## Technical Product Notes

NV Plus 10.2

DATE CREATED:	TECH NOTE NUMBER:	PREPARED BY:
June 23, 2025 Honegger	TN-NVPlus-10.2-001	Patrick

This Technical note is for the installation of the auxiliary dust cover for the ON/OFF button for the NV Plus-10.2 Battery

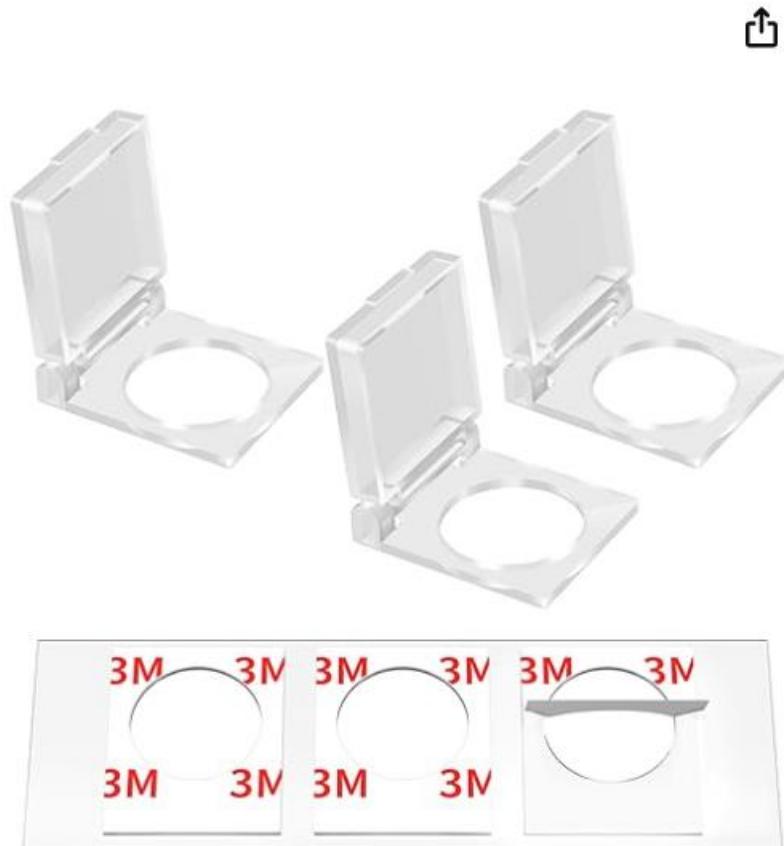
The On/Off button may become stuck in the ON position if excessive airborne particulates are present, or if drilling residue from equipment installed above the NV Plus 10.2 is not properly removed using a vacuum. To mitigate this issue, additional dust protection can be added around the NV Plus 10.2 On/Off button. These protective dust covers are available for purchase on Amazon and can be installed in the field.

DaierTek **22mm** Push Button Cover Child Proof Transparent Safety Power Button Switch Cover Guard Protector for Computer PC Desktop -3Pack

This product comes with double-sided tape for easy installation. No tools are necessary for installation.
